The Town of Hilton Head Island  
**Design Review Board Special Meeting**  
**Friday, May 29, 2020 – 9:00 a.m.**  
**AGENDA**

**Subject:** *Harris Teeter Fuel Center #423 – Sea Pines  
Response to DRB Review Comments*

We are writing in response to the comments made on the site plans for the Harris Teeter Fuel Center #423 on January 14, 2020.

Drawn by: Plastex
Scale: Varies
Date: 5-1-20
Job Description
HT 423 Ice Chest Shelter
Sheet Description
Plan and Section Views
Sheet Number
1.0

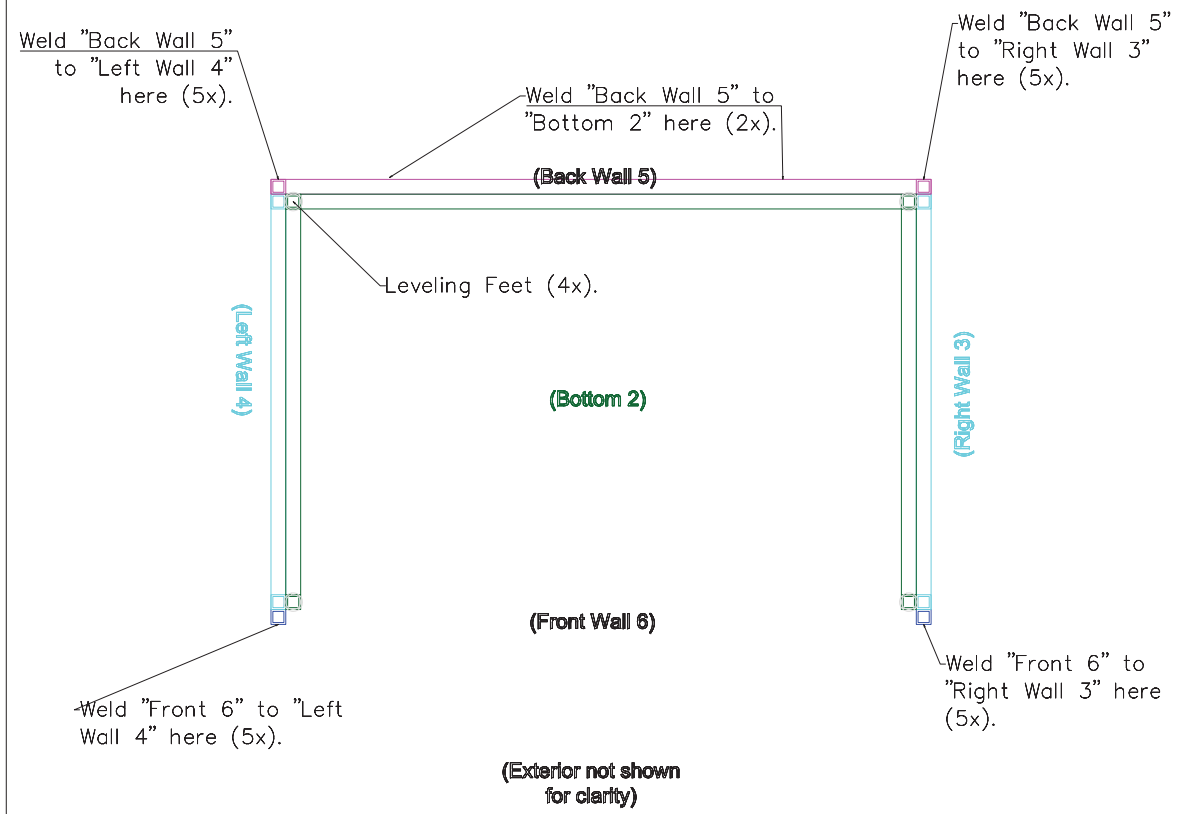
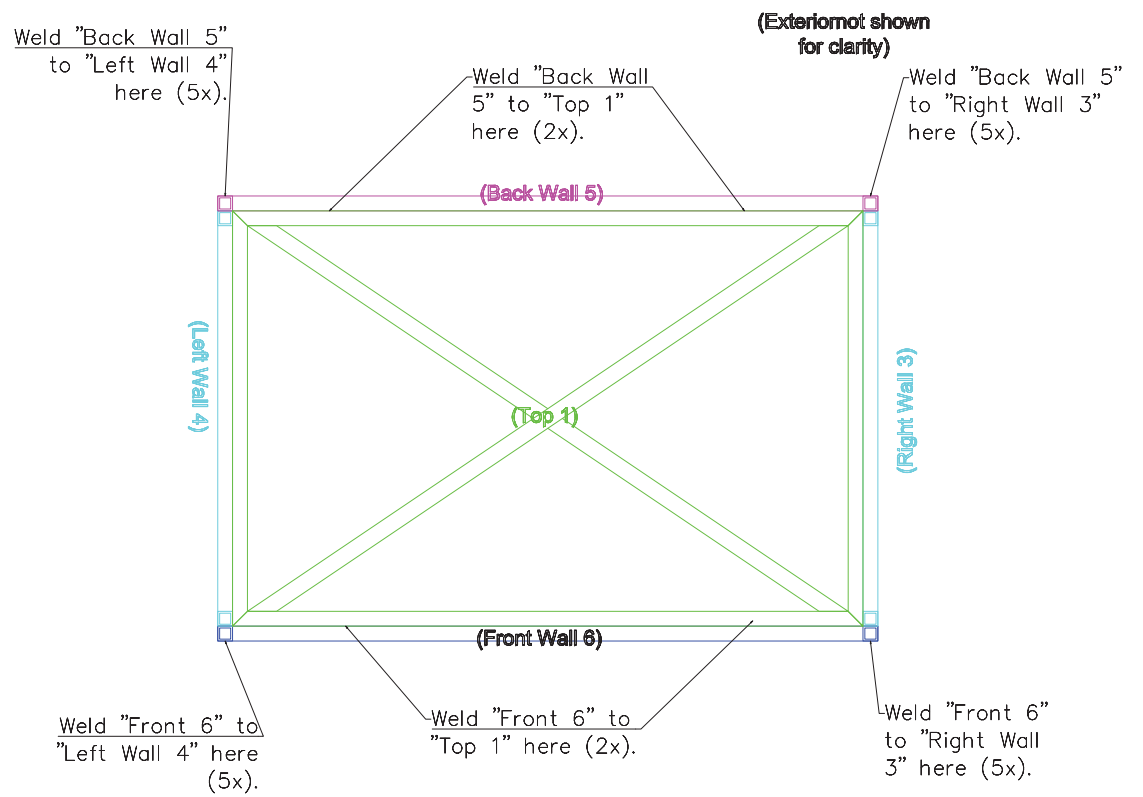
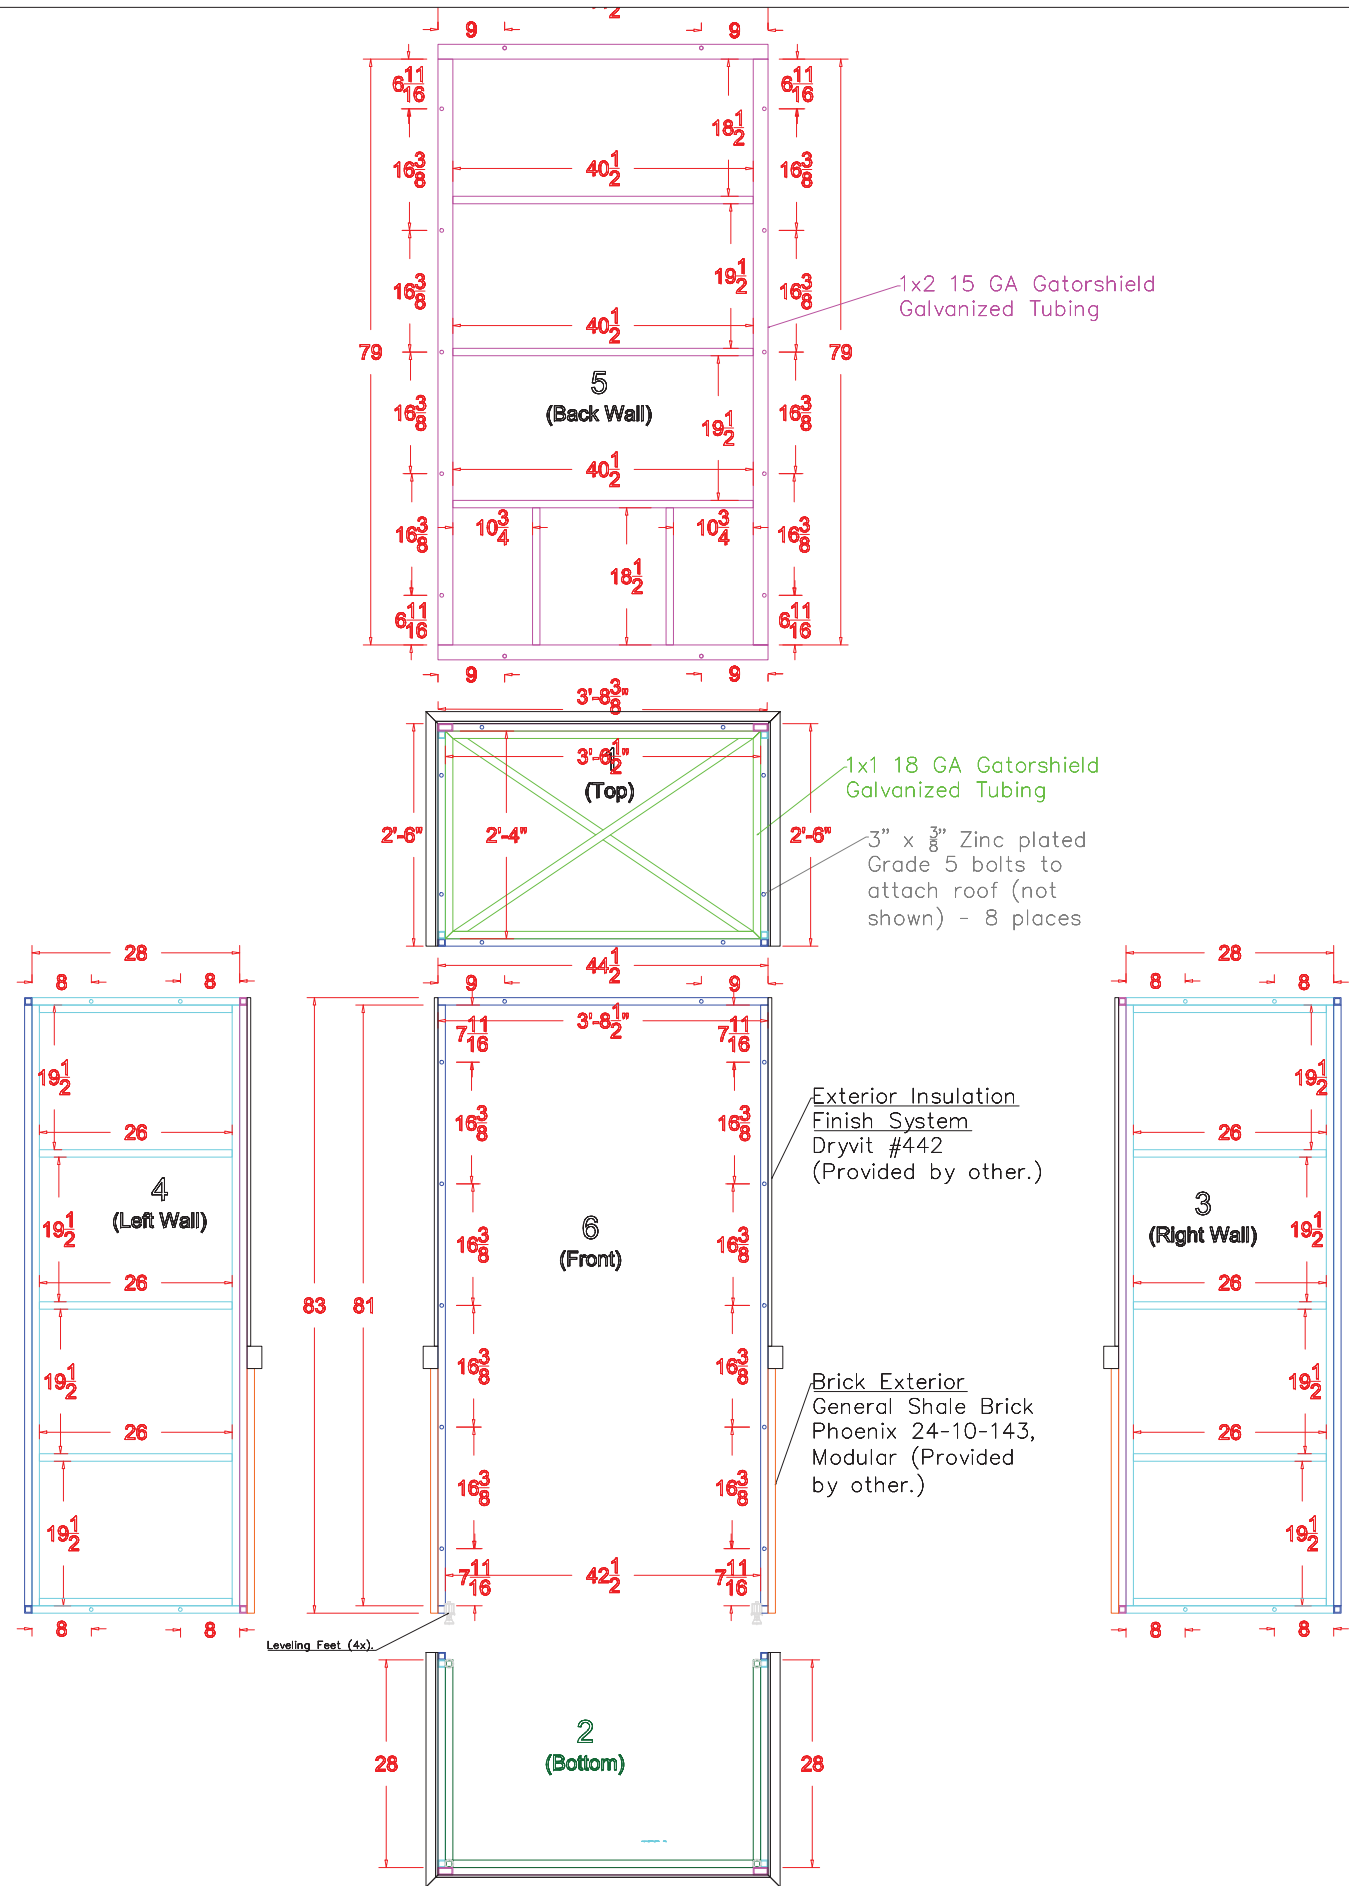
3. Utilities and equipment are concealed from view. The plans label the Blue Rhino enclosure as a “Phoenix Brick Enclosure” but there is no detail for that structure. Does it match the dumpster enclosure? If so label accordingly or provide detail.

5. Accessory elements are designed to coordinate with the primary structure.
  - a. Provide a detail of the “phoenix Brick Enclosure” in front of the kiosk under the canopy. It appears to be a free standing vending unit in the illustrations.

***Response:** Please see attached enclosure details by Plastex.*

**Response:** Enclosure plans have been provided. The enclosures will operate as if “attached” to the kiosk. However, the roof is not proposed to be shared due to two concerns. 1) There will be a large opening that will be unoccupied between the top of the merchandiser and the roof line. This will be visually unappealing as well as maintenance issue with potential bird nesting. 2) The roofline of the entire side of the kiosk extending out to cover the merchandisers is a potential hazard for large vehicles to clip the roof while circulating the site. 3) To maintain the true gable roof as requested by the board, this was not feasible.

**Response:** Enclosure drawings have been provided to show that they will include a brick base and EIFS top to match the kiosk elevations.

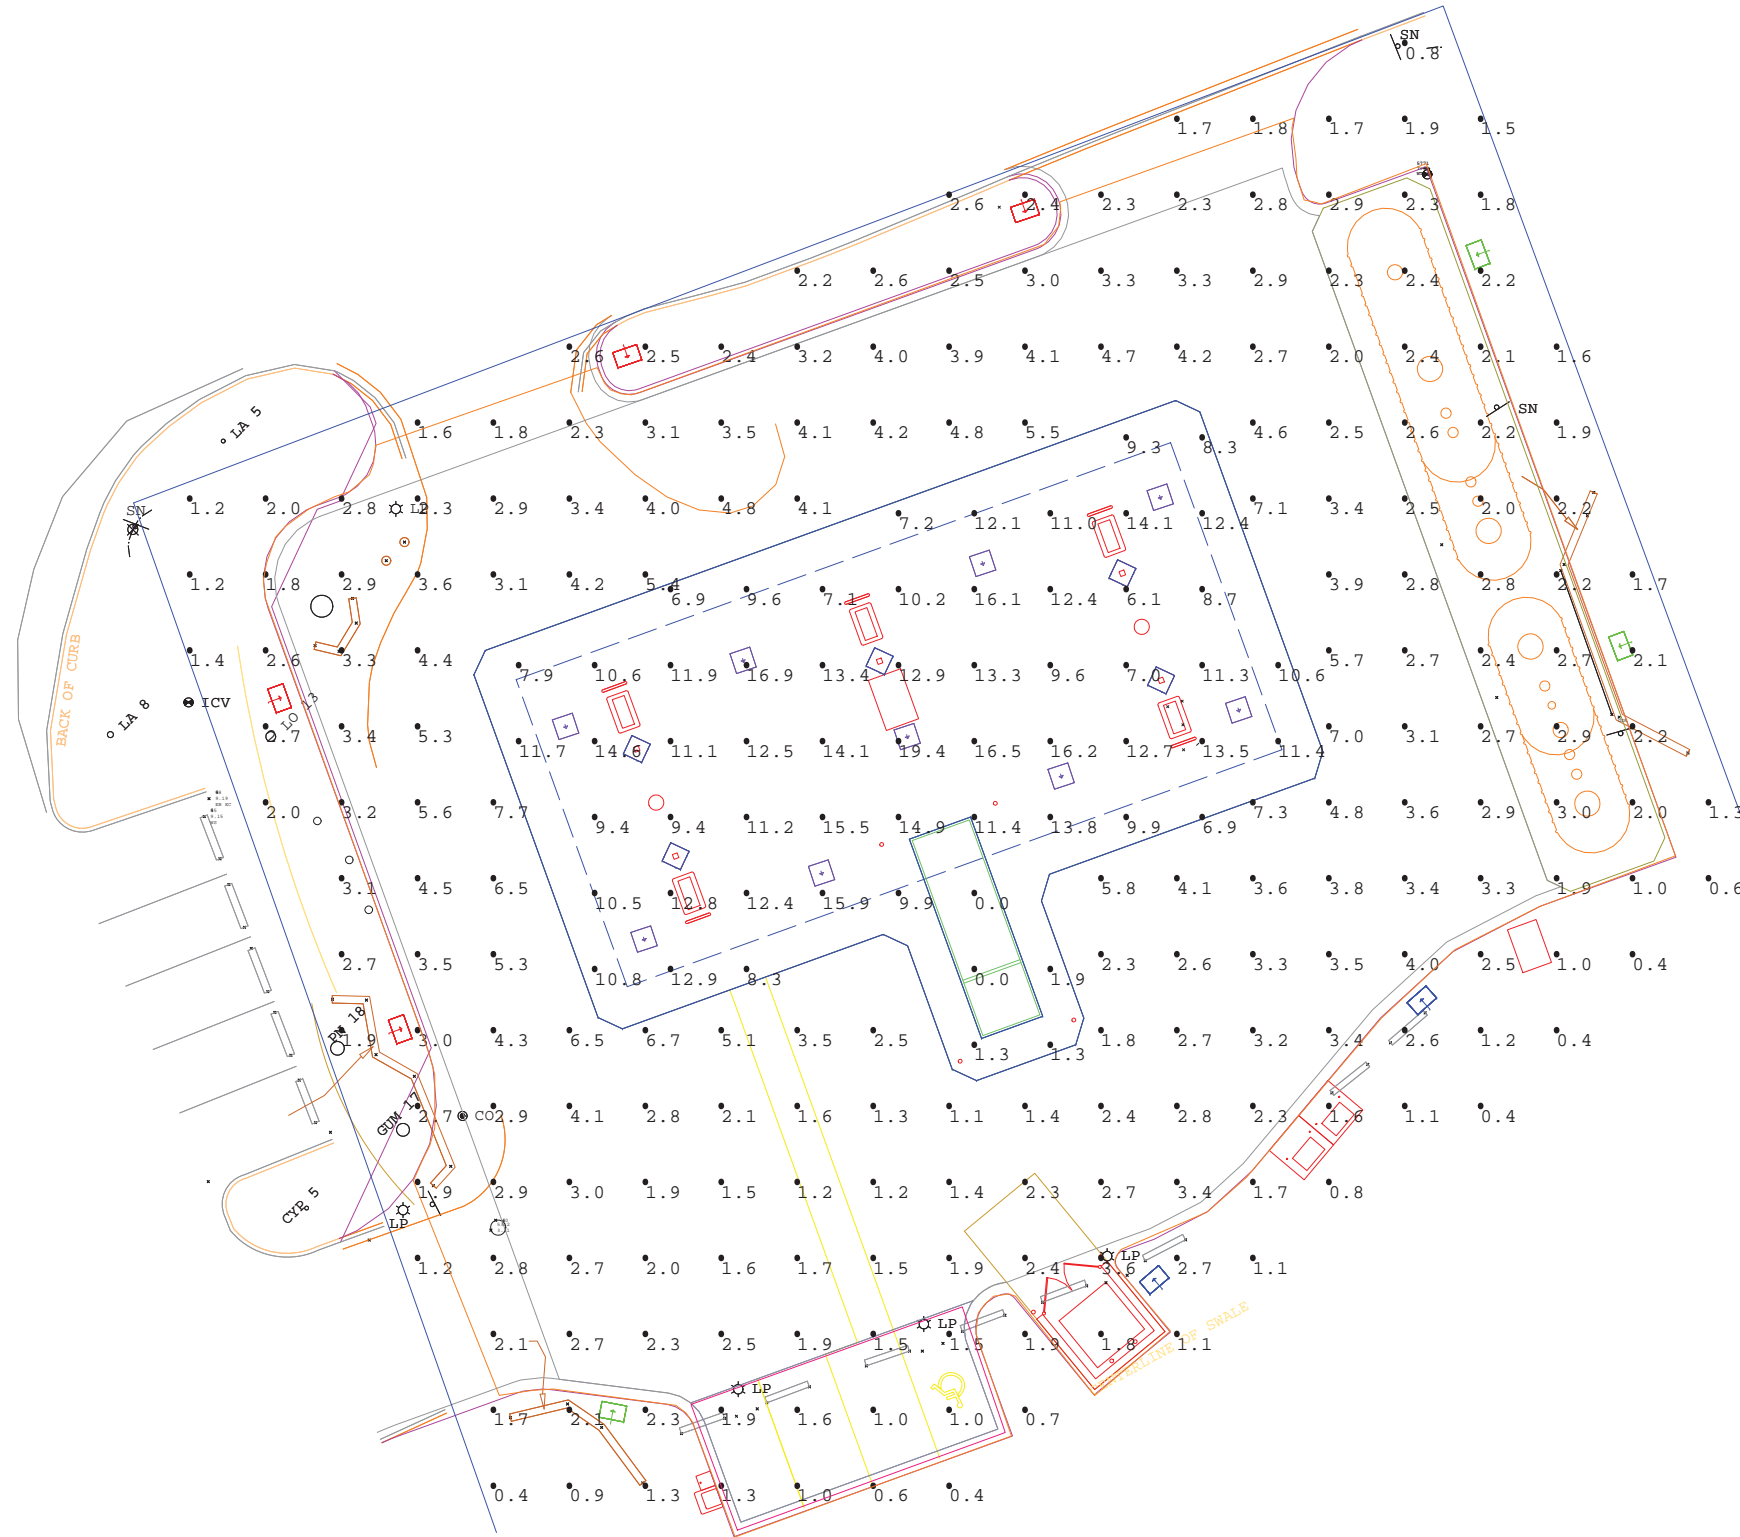
5. A lighting plans showing foot-candles, light temperature and fixture specifications / cut sheet should be provided at Final DRB review.

**Response:** *A lighting plan showing TRC required foot-candles and 3000 K light temperature has been included in this submittal. Lighting specifications have also been provided.*

**Response:** Please see attached lighting plan, and table indicates the Nonresidential Parking area to be average of 1.33 footcandles.
